# HISTORIC AND DESIGN REVIEW COMMISSION

December 07, 2022

**HDRC CASE NO:** 2022-544  
**ADDRESS:** 354 NORTH DR  
**LEGAL DESCRIPTION:** NCB 7014 BLK LOT 18, E 5 FT OF 17 & W 5 FT OF 19  
**ZONING:** R-6, H  
**CITY COUNCIL DIST.:** 7  
**DISTRICT:** Monticello Park Historic District  
**APPLICANT:** Luis Valderas  
**OWNER:** Luis Valderas  
**TYPE OF WORK:** Roof replacement and roof form modification to rear accessory structure  
**APPLICATION RECEIVED:** November 01, 2022  
**60-DAY REVIEW:** Not applicable due to City Council Emergency Orders  
**CASE MANAGER:** Rachel Rettaliata

1. Replace the existing composition shingle roof on the garage with a corrugated metal roof to match the patio cover and the rear accessory structure.
2. Modify the front gable roof form to a flat roof form and raise the height of the top plate of the garage.

## Building Elevation drawing

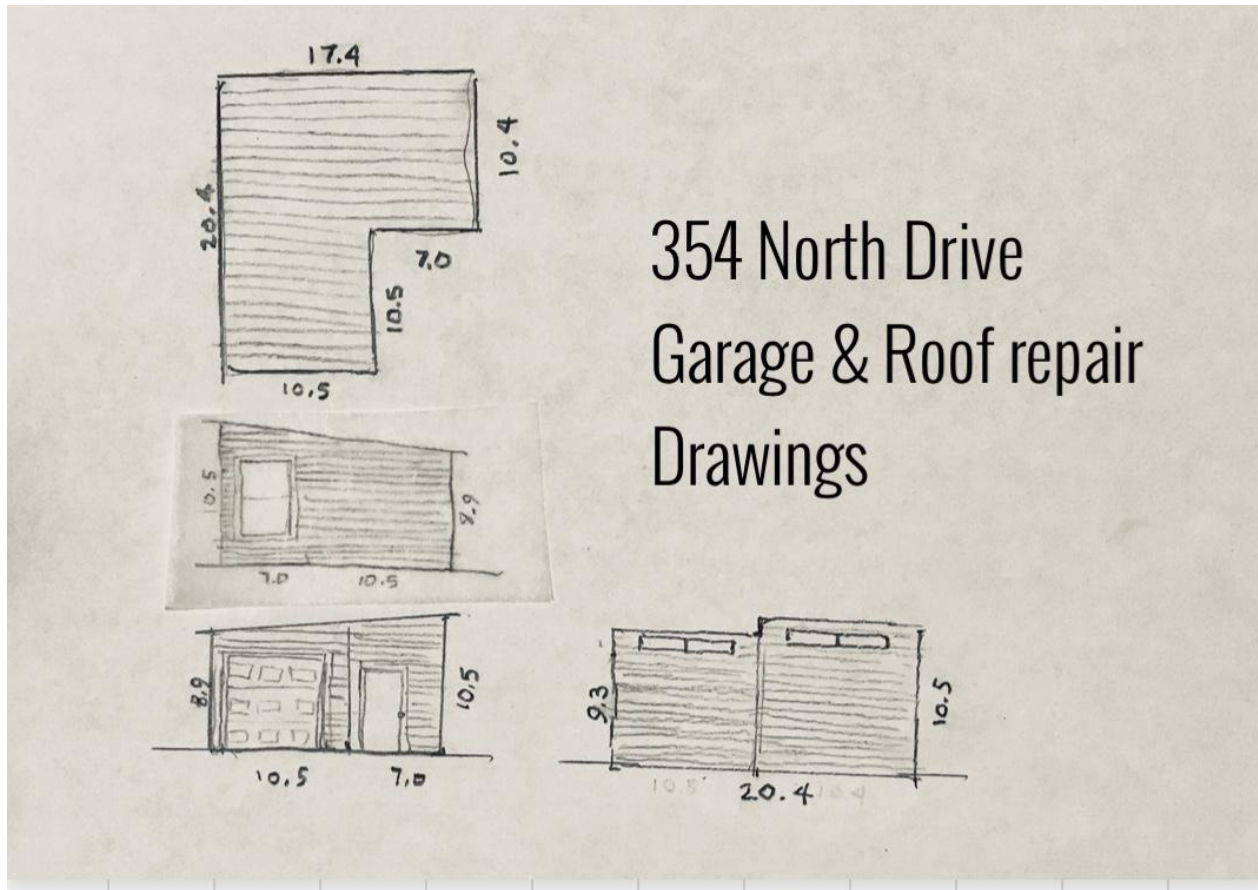
- c. ROOF: MATERIALS – The applicant has proposed to replace the composition shingle roof with a corrugated metal roof to match the existing patio cover. Guideline 3.B.iv for Exterior Maintenance and Alterations states that roofing materials should be replaced with in-kind materials whenever possible when the roof must be replaced. Historic materials such as slate or clay tiles should be retained and re-used when large-scale replacement of roof materials other than asphalt shingles is required. The existing clay roof tiles are severely damaged and require replacement. Furthermore, Guideline 3.B.iv states that new roofing materials should match the original materials in terms of their scale, color, texture, profile and style or materials should be selected that are consistent with the building style when in-kind replacement is not possible. Per the 1951 Sanborn Map, the roofing material at that time was a composition shingle roof. Staff finds the proposal inconsistent with the Guidelines.

Item 1, staff does not recommend approval of the roof material change on the rear accessory structure based on findings a through c. Staff recommends that the applicant installs a replacement composition shingle roof to match the previously existing roof.

## Elevation drawings, floorplans, and architectural drawings

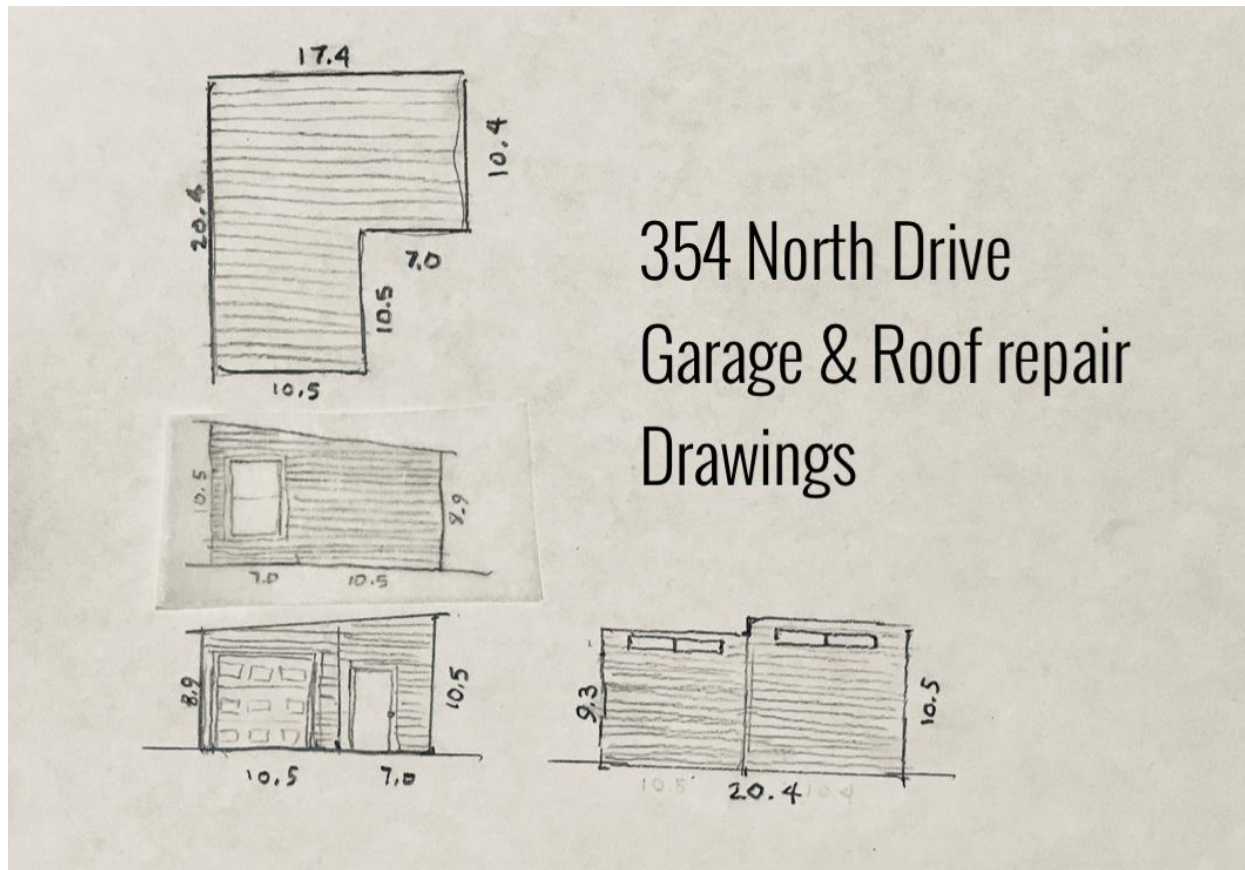
- d. ROOF: FORM – The applicant has proposed to modify the front gable and shed roof forms to a flat roof form to match the existing rear carport structure and to raise the top plate height. According to Guideline 3.B.ii for Exterior Maintenance and Alterations, the original shape, line, pitch, and overhang of historic roofs should be preserved when replacement is necessary. Additionally, Guideline 3.B.iii states that distinctive roof features such as cornices, parapets, dormers, open eaves with exposed rafters and decorative or plain rafter tails, flared eaves or decorative purlins, and brackets with shaped ends should be preserved and repaired. Staff finds the proposal inconsistent with the Guidelines and finds that the original roof form should be preserved.

Item 2, staff does not recommend approval of the roof form modification based on finding d. Staff recommends that the applicant retains the front gable and shed roof forms.
